Canoga Transportation Corridor

Final Environmental Impact Report Addendum

December 15, 2008

Figure 3-1. Illustration of the Canoga Busway Option 5

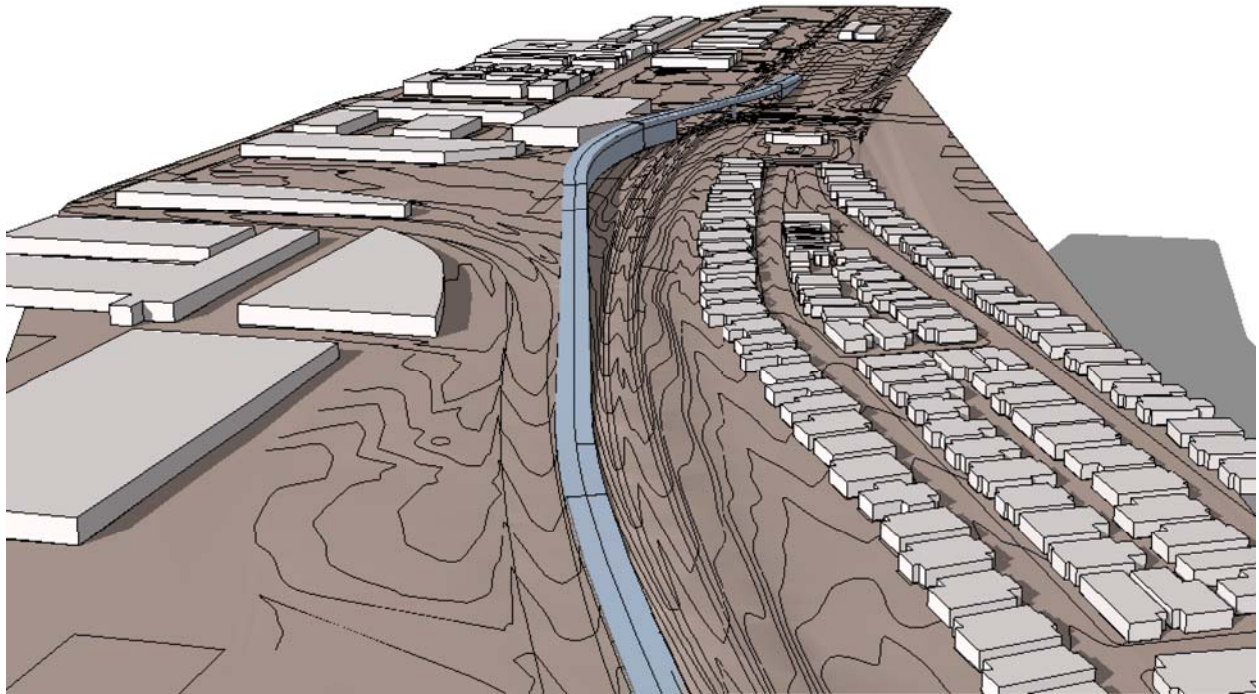
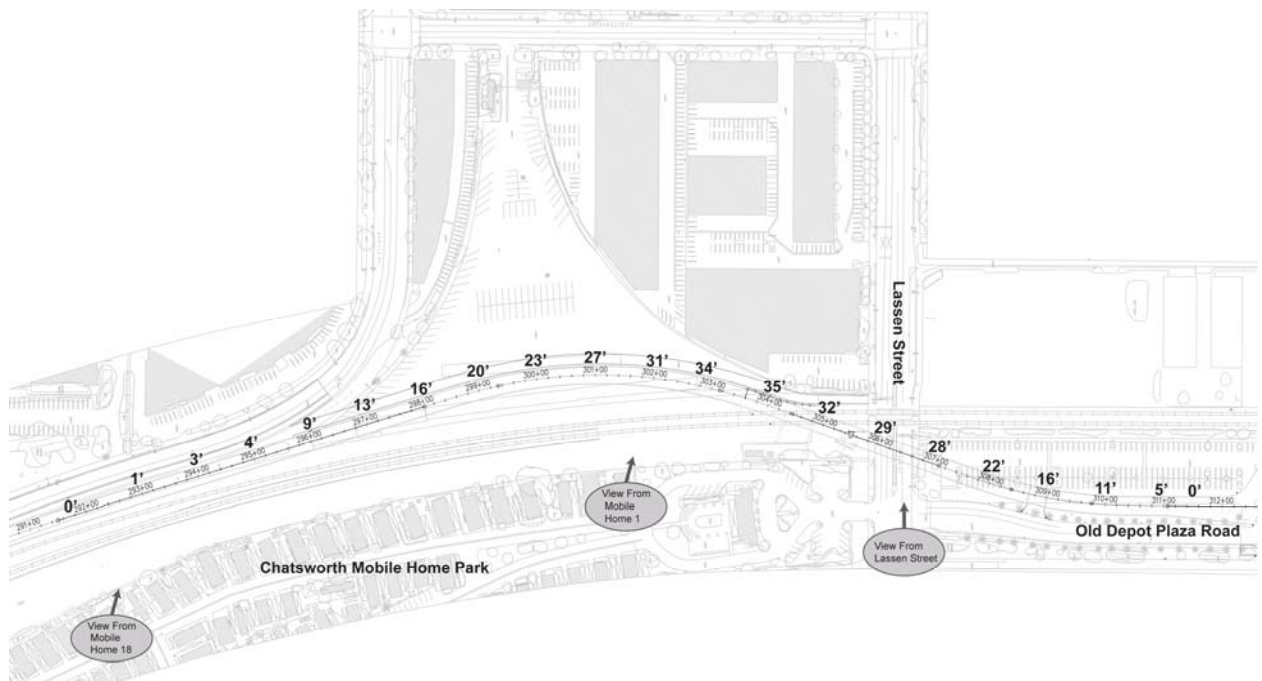
In response to the comments submitted on this issue and in recognition of the desire to reduce the massing of the Lassen Street/Railroad overcrossing and approach, the consultant team further clarified the analysis of the visual environment and potential mitigation measures based on the Preliminary Engineering Plan and Profile drawings of Option 5 bridge, which was selected as the locally preferred alternative. **Figure 3-1** is a 3d illustration showing the relationship of the overcrossing and the embankment leading to the overcrossing. **Figure 3-1a** shows a plan view of the LPA on the west side of the railroad tracks away from the mobile homes. The approximate height of the road bed on the embankments and bridge are also shown.

Public Right-of-Way - Lassen Street is a public right-of-way and currently there are views of the Santa Susana Mountains to the west as shown in existing condition photos. See **Figure 3-1b** taken from the entrance to the mobile home park, south of Lassen Street. **Figure 3-1c** is a view standing on the sidewalk at the mobile home park entrance with the proposed bridge over Lassen Street; Santa Susana Mountains are visible under the bridge. Further east from the bridge on Lassen Street, the bridge would temporarily block views of the mountains for motorists and pedestrians. Overhead utility poles/lines directly under/adjacent to the bridge will be undergrounded, some billboards potentially removed, and railroad gates and lights potentially relocated thereby improving the overall visual environment. Potential mitigation (see MM 4.6-5) for the massing of the bridge structure would be to provide variations in the shape of the bridge and railings to create shadow lines and openings. **Figure 3-1c** illustrates a bridge design that is consistent with this mitigation measure.

Figure 3-2 Location of the mobile homes #1 and #18

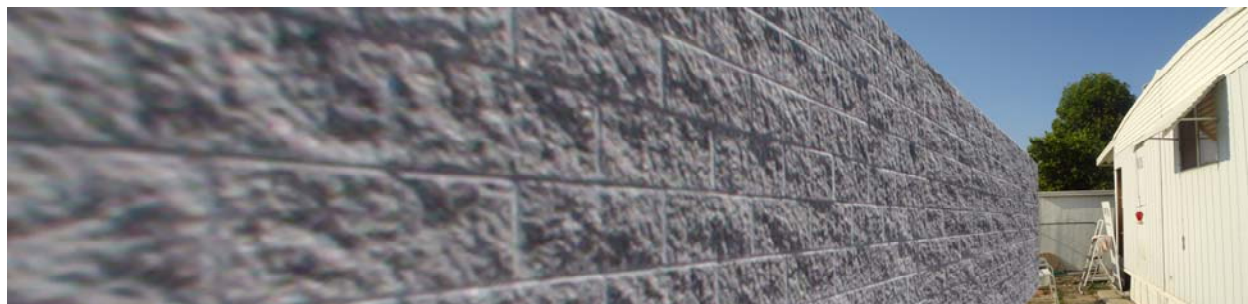
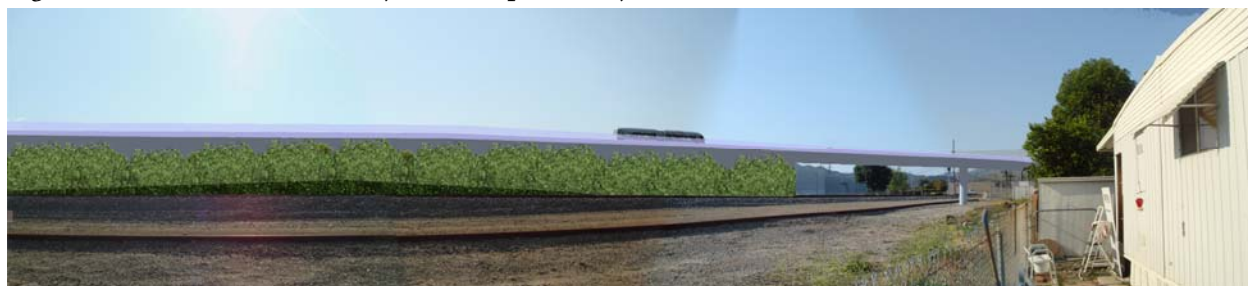
Private Property - In response to the comments received from the residents of the Chatsworth Mobile Home Park, the consultant team also analyzed the views of Option 5 from mobile homes # 1 and 18, which are located along the Metro ROW, as shown in **Figure 3-2**.

- **Figure 3-2a** is the existing condition looking northwest from mobile home #1 (the closest mobile home to Lassen Street which fronts on the Metro ROW looking towards the mountains to the northwest). The existing industrial building south of Lassen Street partially blocks the views of the mountains. Any new industrial buildings west of the railroad tracks will further block views of the mountains.
- **Figure 3-2b** shows an 8 ft privacy wall as requested by the mobile home park residents which would block the view of the mountains from the backyard of their mobile homes.
- **Figure 3-2c** shows the elevated busway with retaining wall, embankment, and vines planted against the retaining wall that would soften views of the embankment

84-4 Please see Topical Response 1. An 8 ft wall as requested by mobile home residents, illustrated in Figure 2b and 3a along the Chatsworth Mobile Home Park could have vines to prevent graffiti and/or graffiti resistant surfacing. However, the ROW adjacent to the mobile home park is owned by Union Pacific (UP) and therefore landscaping may not be permitted by UP adjacent to the wall.

Figure 4: Replacement Parking for Option B and D north of the Chatsworth Metrolink Station

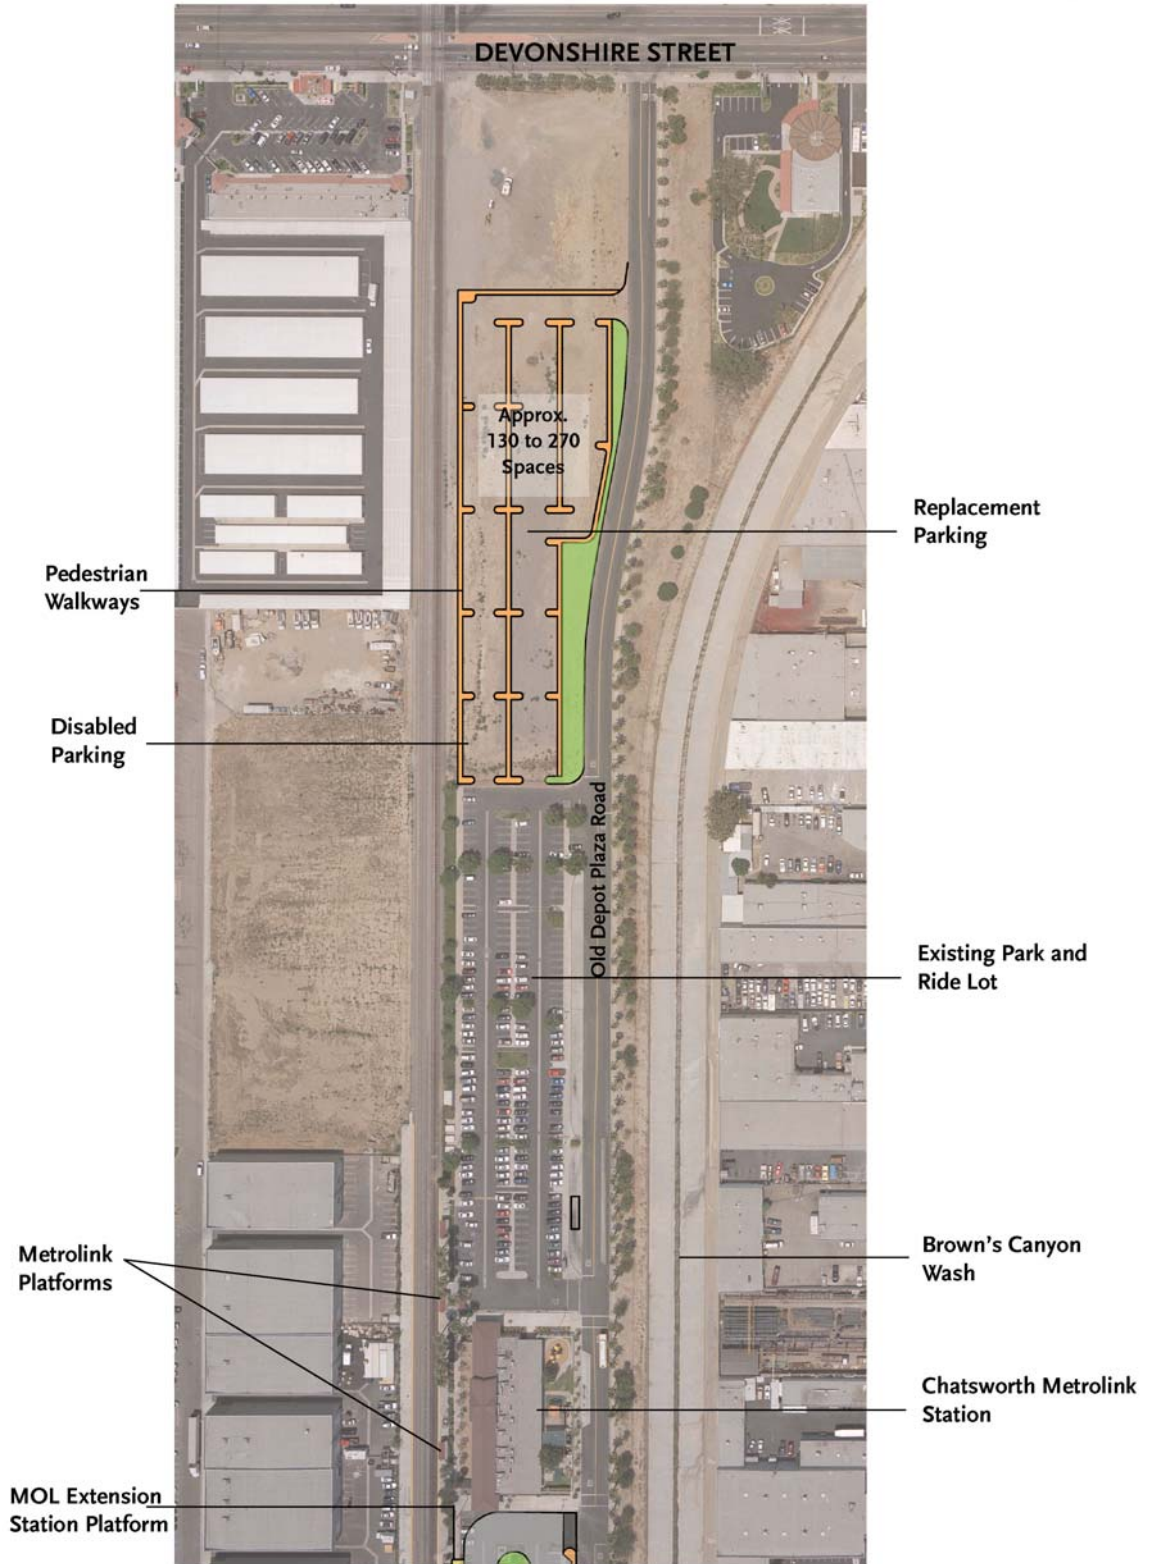
108-5 Please see Topical Responses 1 and 2. As suggested by the commenter an 8 ft privacy wall is under consideration. Parking removed for the overpass would be replaced north of the Chatsworth Metrolink Station, and is illustrated in **Figure 4** on the following page.

Revised Figure 3-31

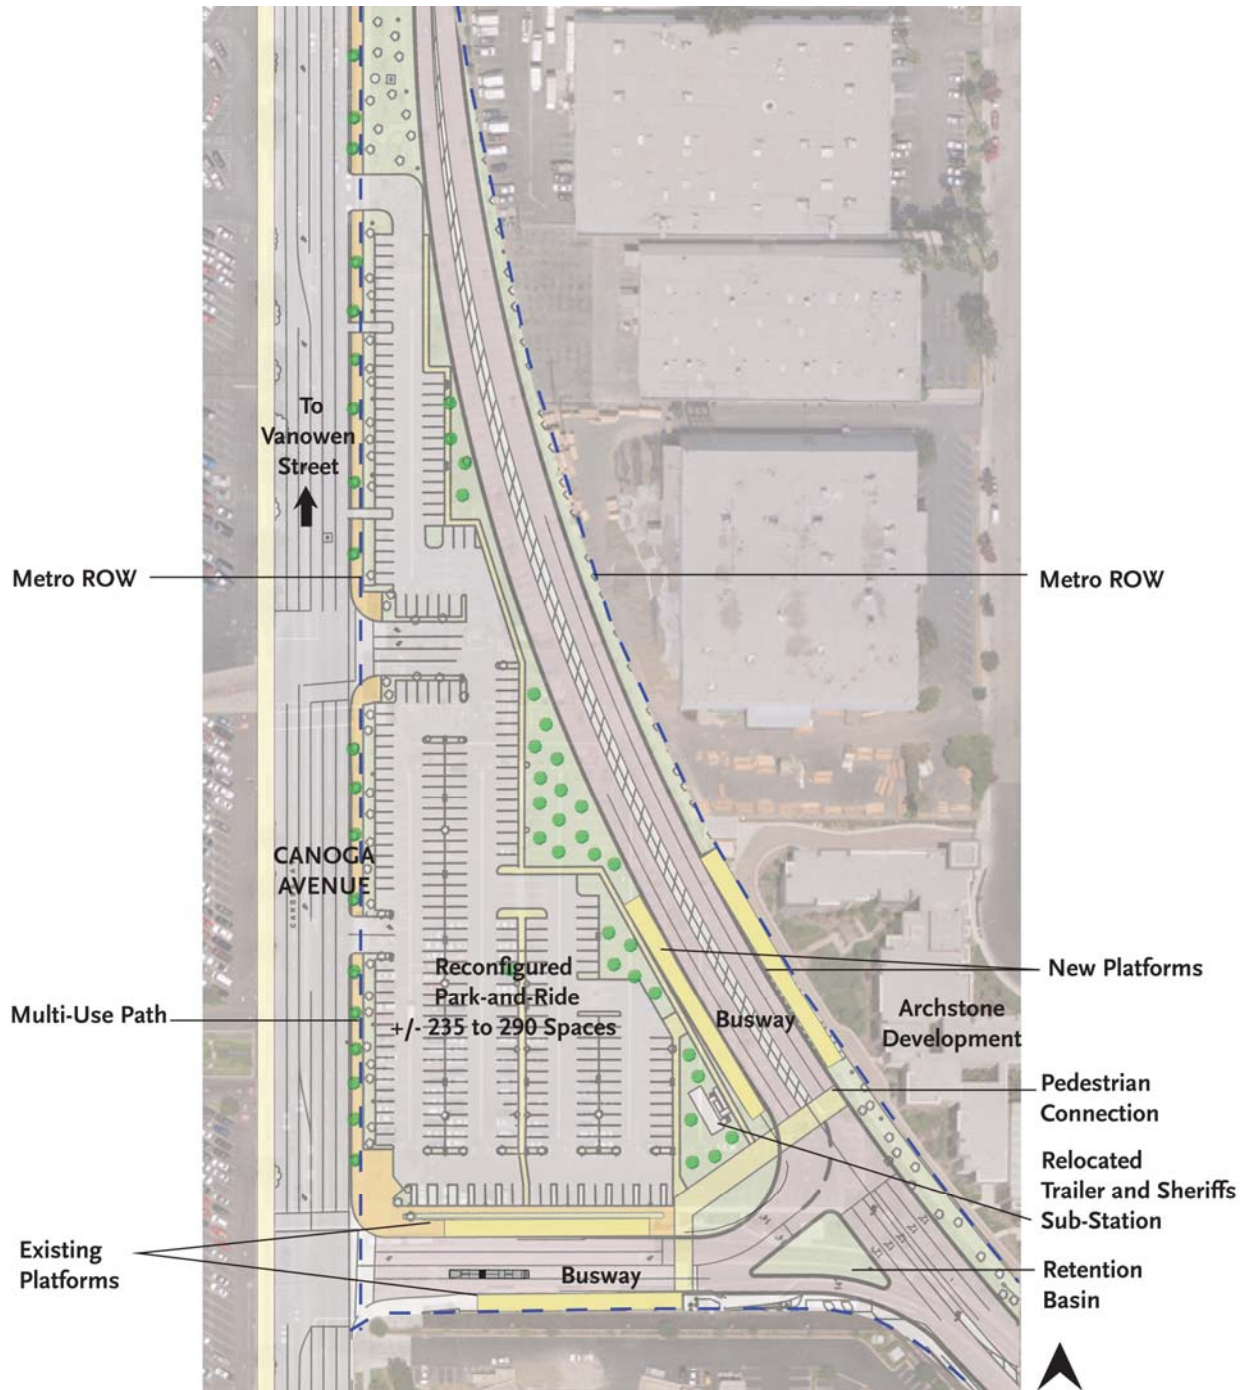
Page 3-50, Figure 3-31 is revised as follows (see graphic on following page):

The "Marilla" parking lot is conceptually illustrated below:

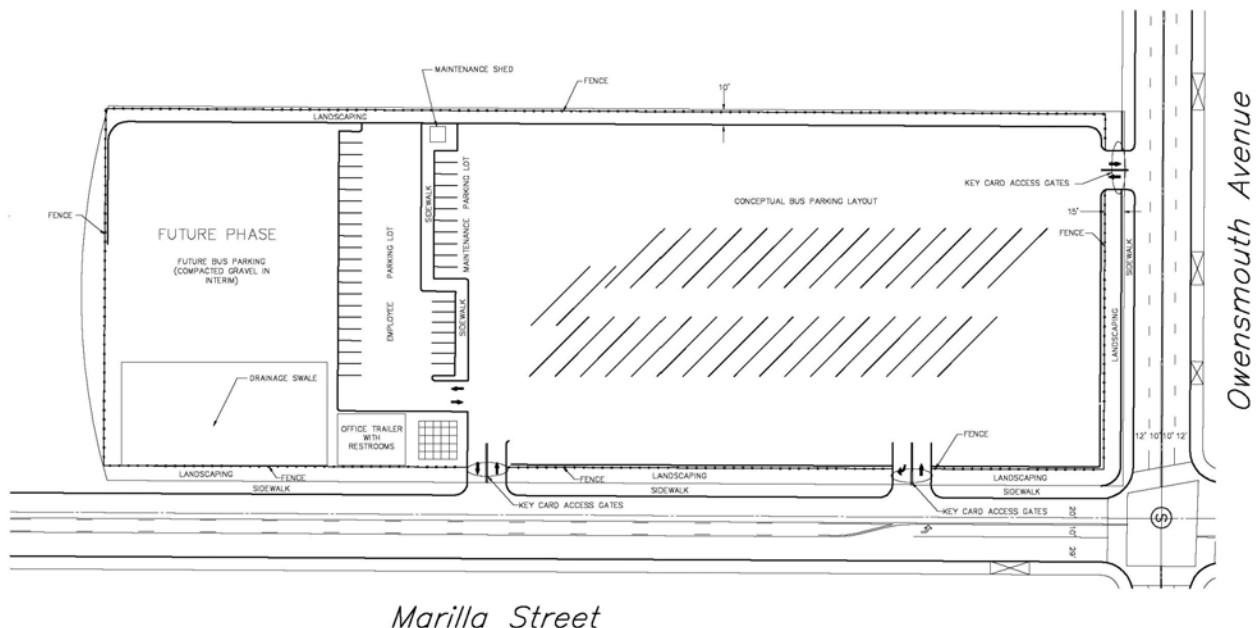
Page 3-54, add the following sentence and graphic at the end the second paragraph:

Revised Figure 4.7-16

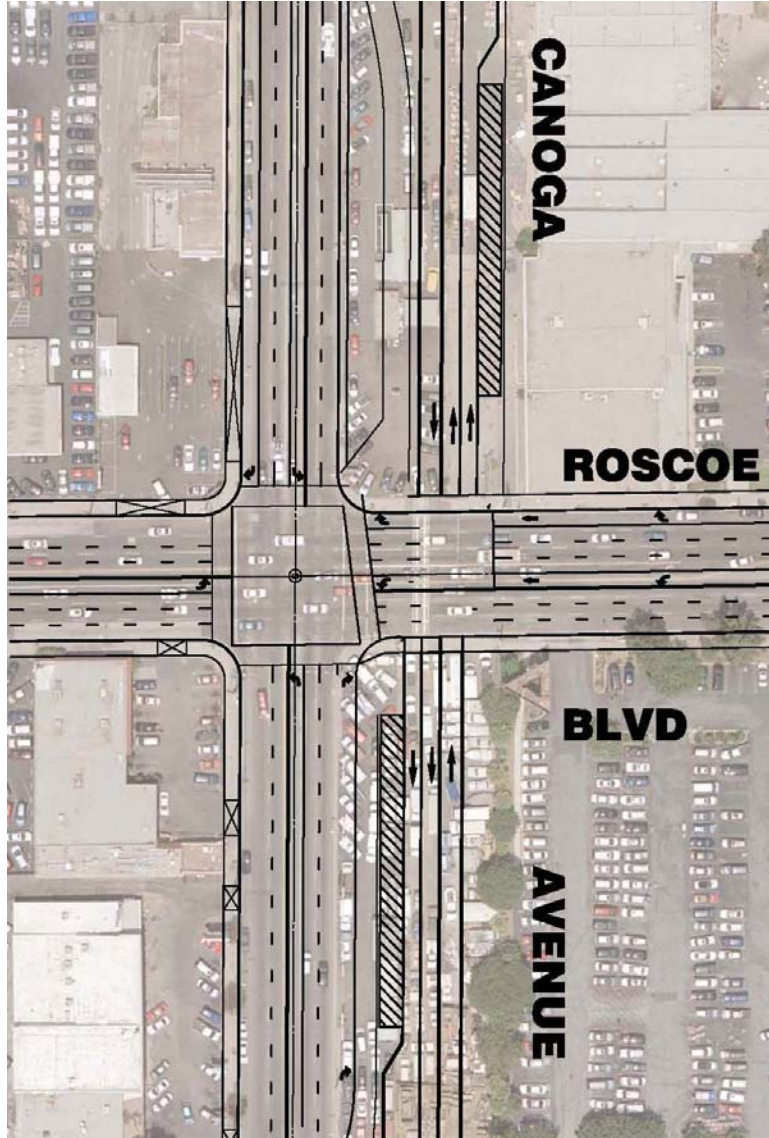
Page 4.7-49, Figure 4.7-16, is revised as shown on the next page.

Revised Figure 4.7-18

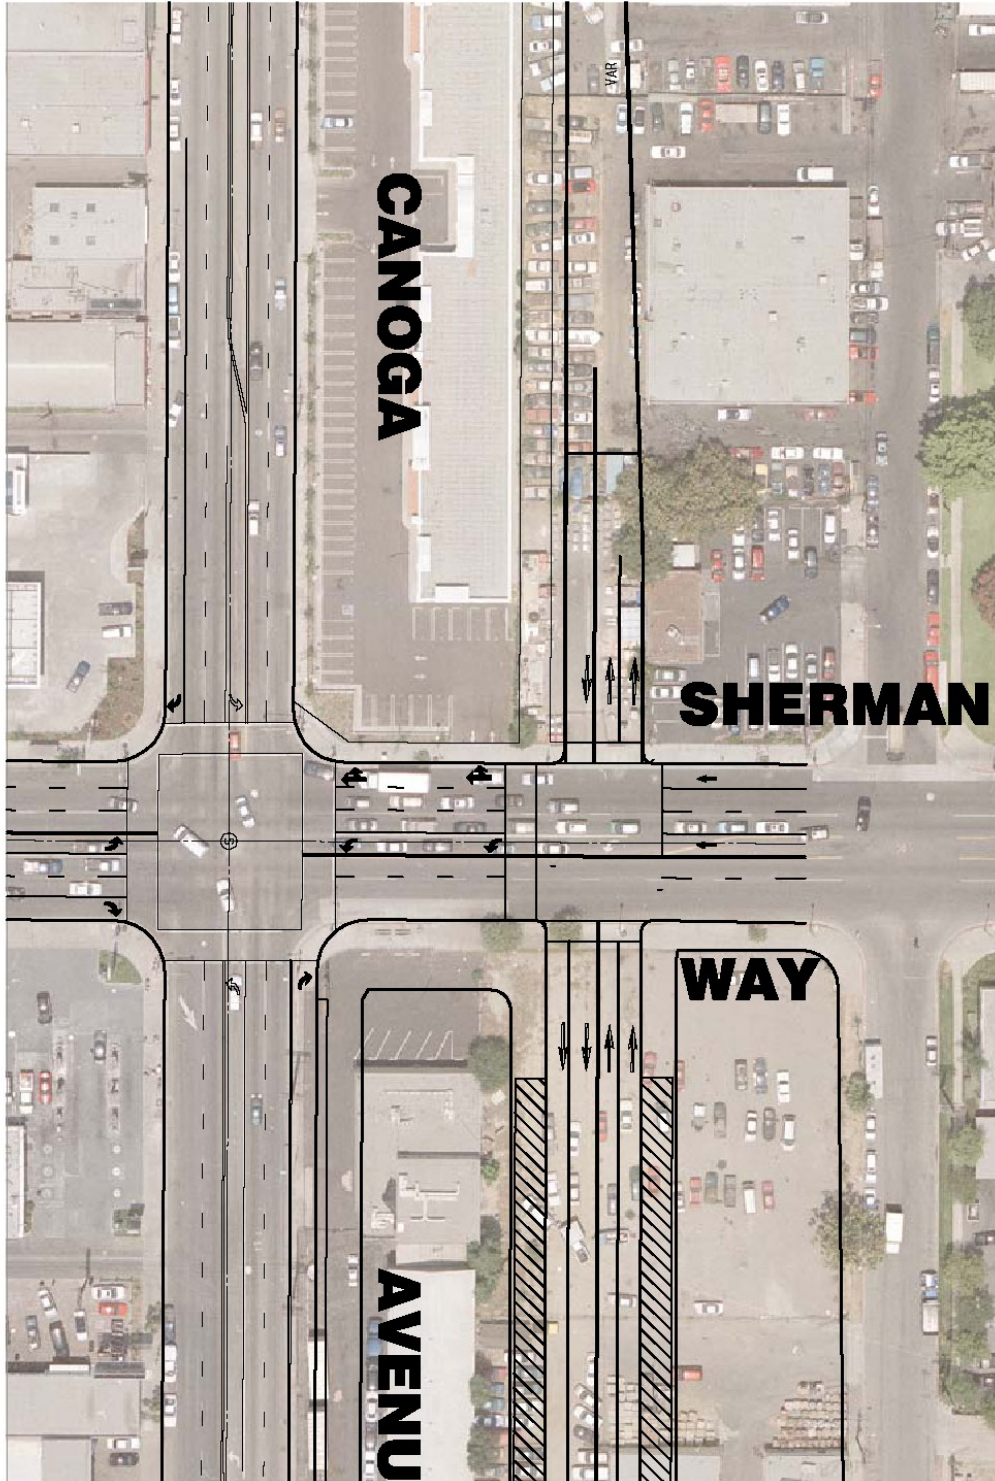
Page 4.7-51, Figure 4.7-18 is revised as shown on the next page.
